SYDNEY PLANNING PANEL **(Sydney Western City)**

SPP No.	2017SSW030 DA
DA Number	2882/2016/DA-C
Local Government Area	Campbelltown
Proposed Development	Demolition of all existing school buildings and removal of trees at Bardia Public School, construction of new school buildings, sports field, games court, play areas and landscaping
Street Address	Bardia Public School - Lot 1 DP 831150 and Lot 106 DP 1200781, Macdonald Road, BARDIA
Applicant/Owner	NSW Department of Education
Number of Submissions	One
Regional Development Criteria (Schedule 4A of the Act)	Crown development with a capital investment value over \$5 million
List of All Relevant s79C(1)(a) Matters	<ul style="list-style-type: none"> • State Environmental Planning Policy (Infrastructure) 2007 • State Environmental Planning Policy 55 – Remediation of Land • State Environmental Planning Policy (State Significant Precincts) 2005 • Rural Fires Act 1997 • Edmondson Park South Development Control Plan 2012

ADDENDUM REPORT

Attachment 3 – Plans showing accessibility of the school's facilities

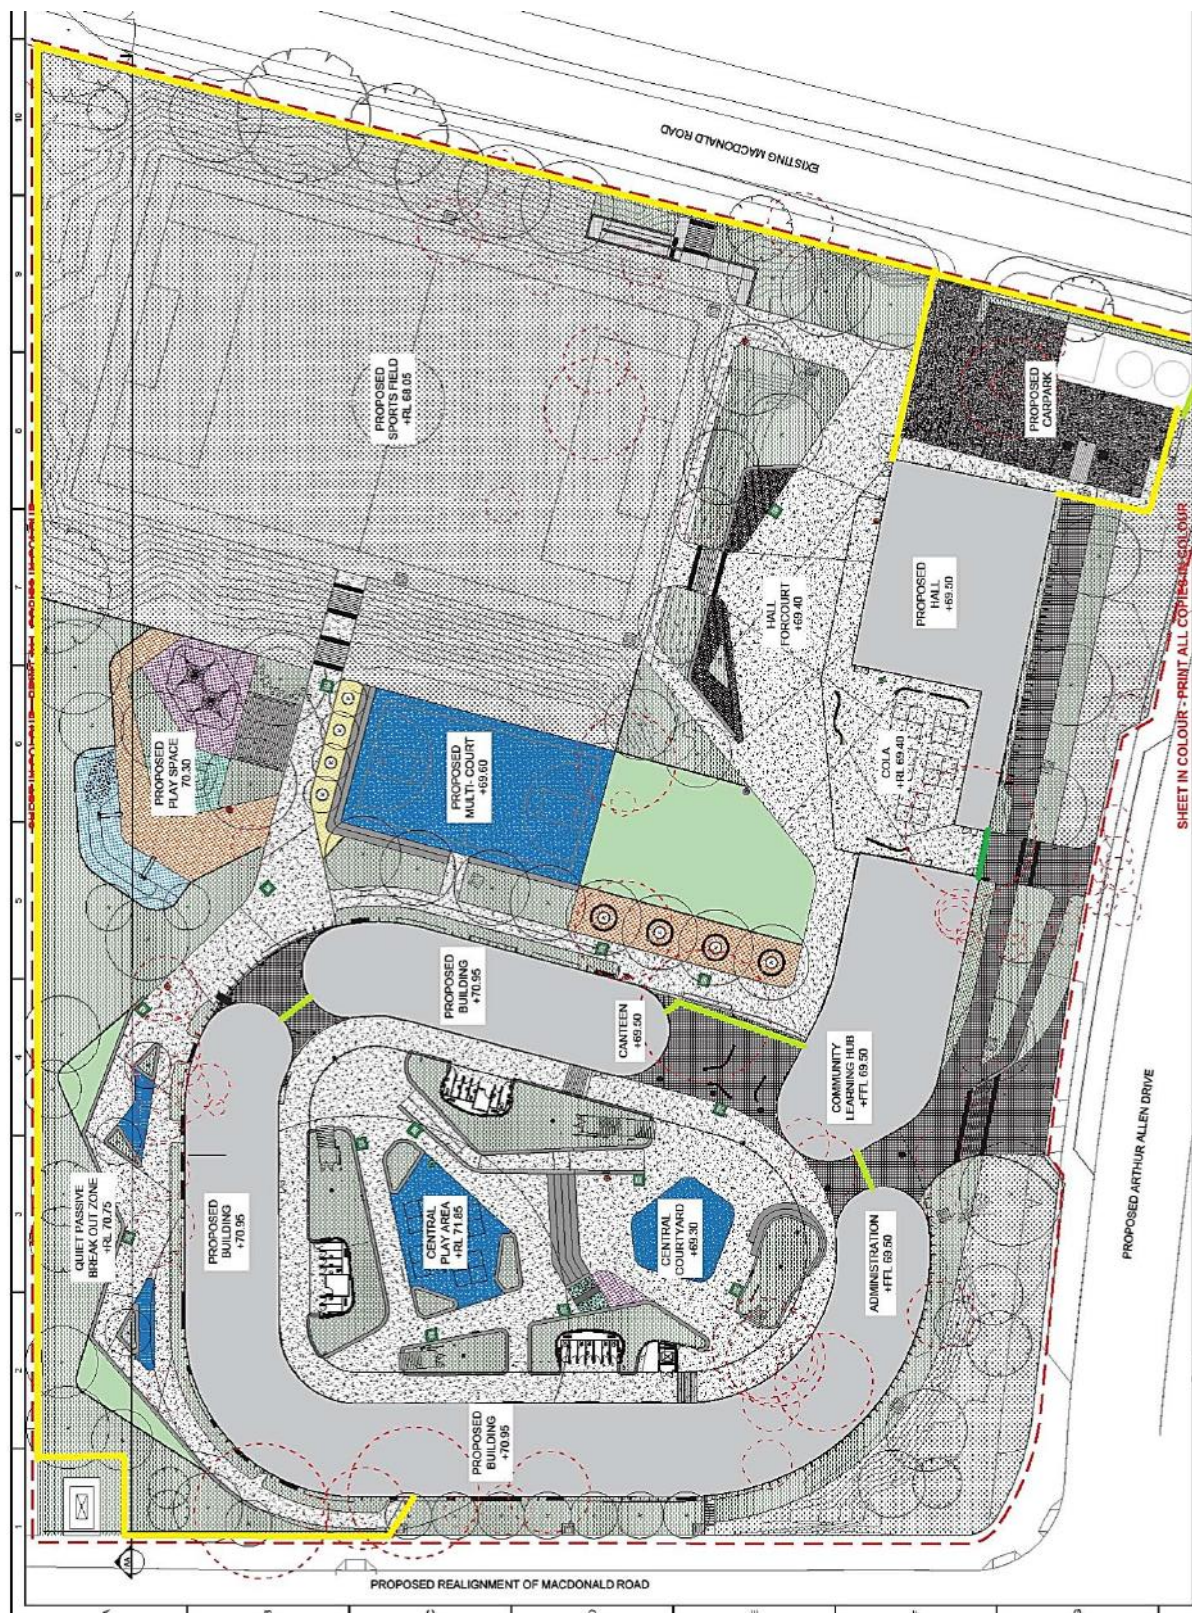
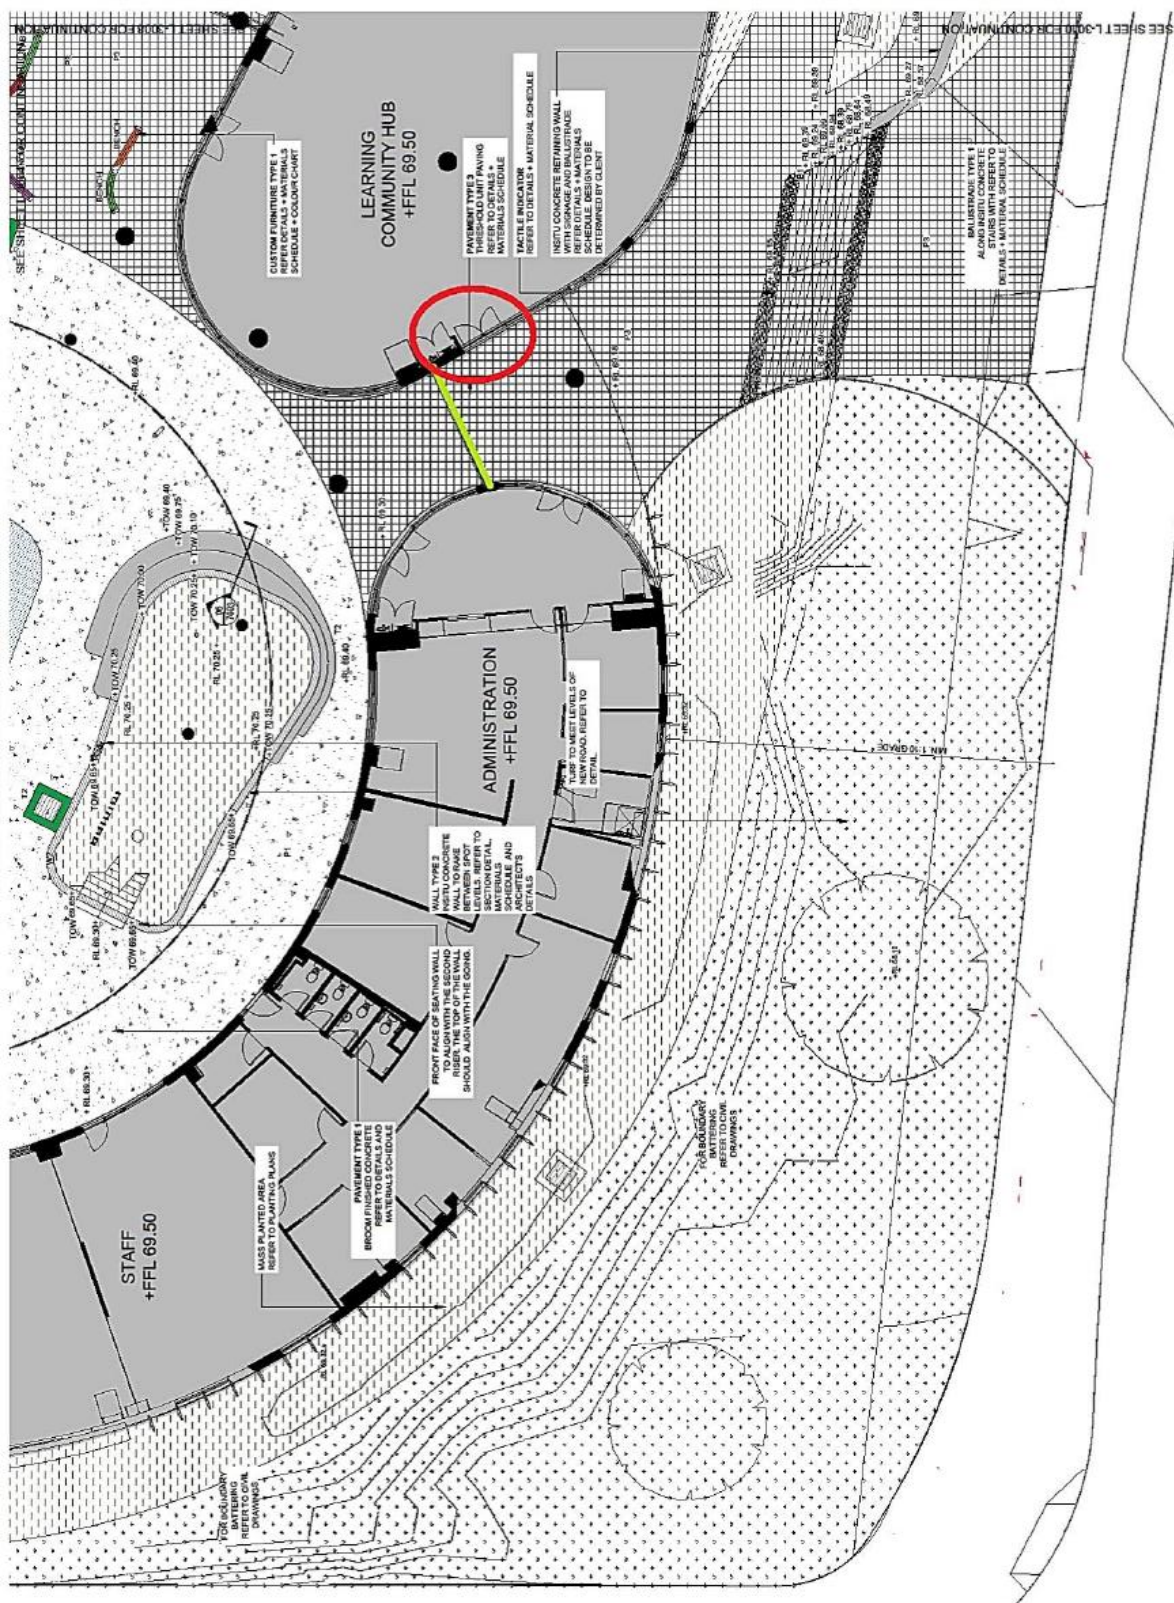
"Full height (2.1m) Securatop fencing has been shown in bright yellow (on the plans shown in Attachment 3). As you can see this encompasses the playing fields and car park. The Arthur Allen Drive and New Macdonald Road facades are exposed to the streetscapes. On review of these drawings it is not feasible to modify this fencing to provide full all-hours access to the playing fields by members of the public. As we discussed this would require a second internal fence to ensure the safety of children using the sports field during school hours. This would not only add significant additional cost but would also violate the design intent of the school and the interactive design that it maintains for movements through the school from area to area."

In this regard, Council's Healthy Lifestyles section (responsible for parks and recreational facilities) advised that based on the design of the school's sports field, it would be unsuitable for use by a sporting club as it would not have lighting and change rooms readily available. Despite this, it could be suitable for infrequent, low-intensity use by members of the public if not for the access issues described above by the Department of Education. Given the abundance of passive recreational opportunities that would be available within the immediate locality by virtue of the ongoing development of the suburb of Bardia and the associated open space and parkland areas, the use of the school's sports field is not

The security shutter for access to the central courtyard is shown in light green. Securapop fencing has been shown in bright yellow.

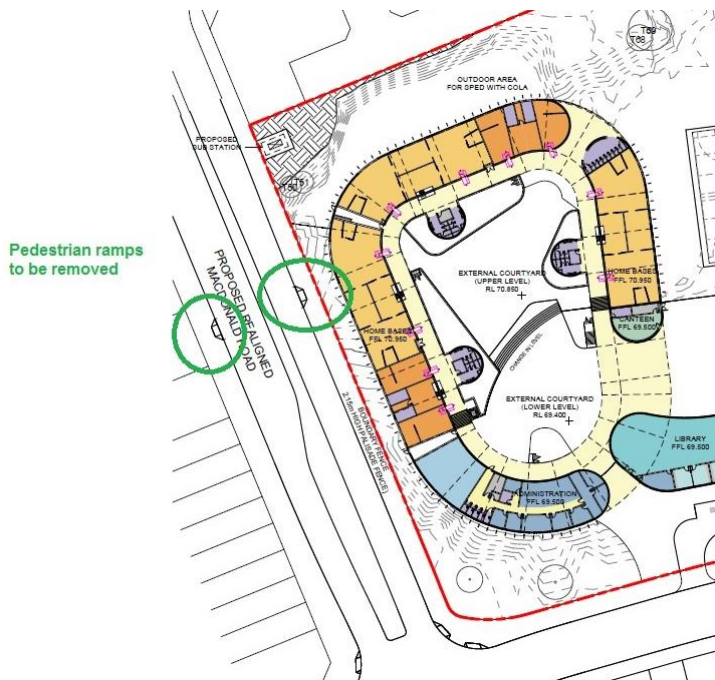
The proposed pedestrian ramps on the realigned Macdonald Road (shown below) are not supported and shall be removed from the submitted plans.
